ECE/TRANS/WP.29/2009/73
9 April 2009

Proposal for Corrigendum 1 to global technical regulation No. 2
(Worldwide harmonized Motorcycle emission Test Cycle (WMTC))

Submitted by the Working Party on Pollution and Energy */

Figure A13-1: Example of a gearshift sketch

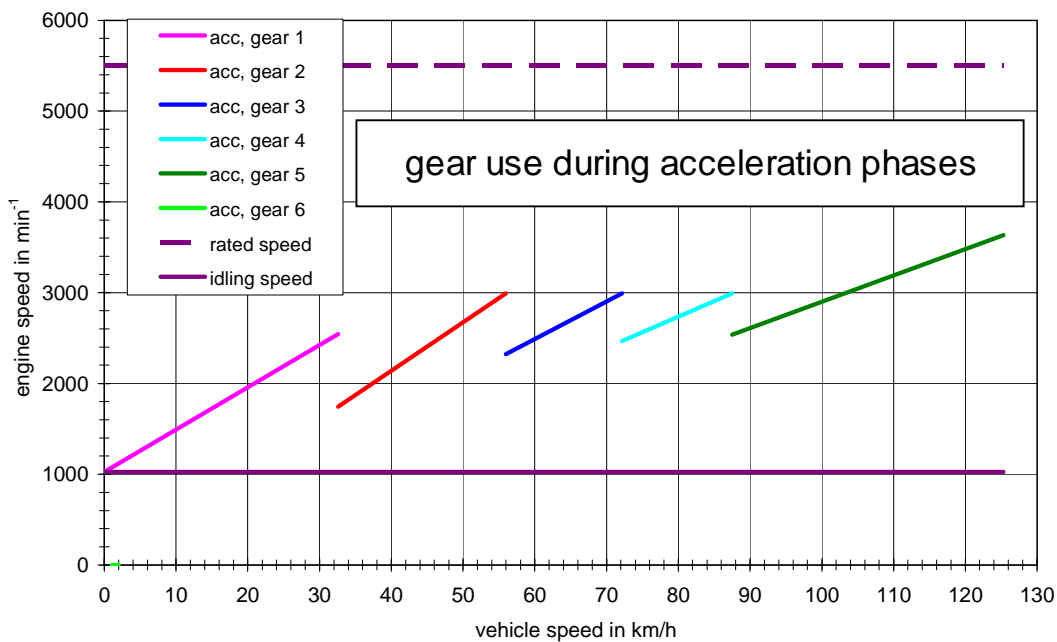
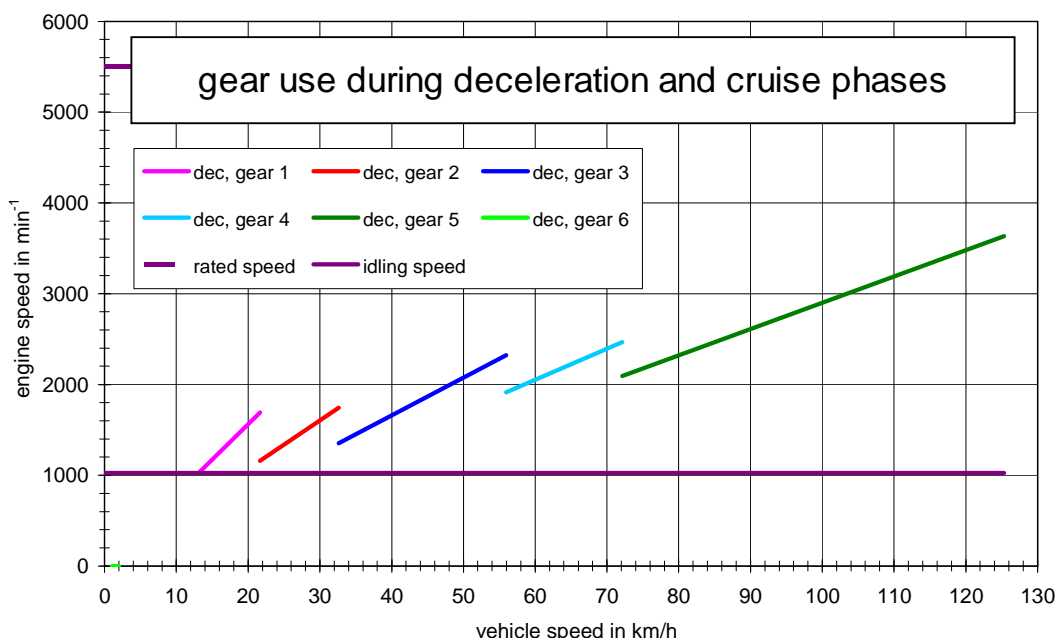
Annex 13, amend to read:

Figure A13-1 shows an example of gearshift use for a small vehicle.

- (a) The lines in bold show the gear use for acceleration phases.
- (b) The dotted lines show the downshift points for deceleration phases.
- (c) The cruising phases the whole speed range between downshift speed and upshift speed may be used.

In case of gradually increase of vehicle speed during cruise phases, upshift speeds ($v_{1 \rightarrow 2}$, $v_{2 \rightarrow 3}$ and $v_{i \rightarrow i+1}$) in km/h may be calculated using the following equations:

Figure A13-2: Example for modified phase indicators

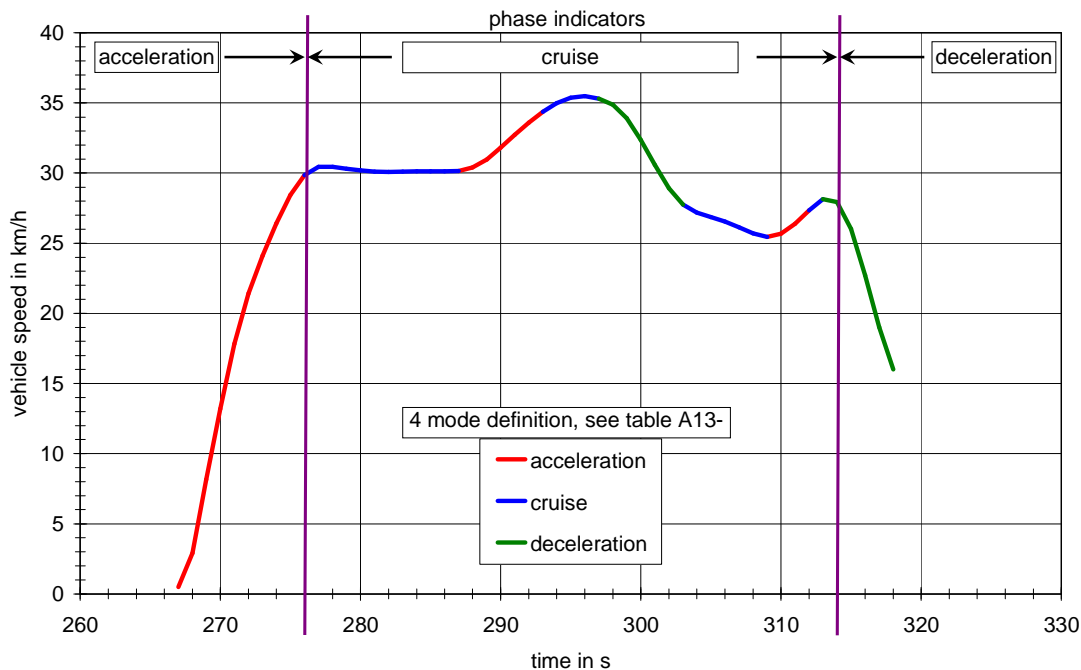
The indicators were then modified in order to avoid frequent changes during relatively homogeneous cycle parts and thus improve the driveability. Figure A13-2 shows an example from cycle part 1.
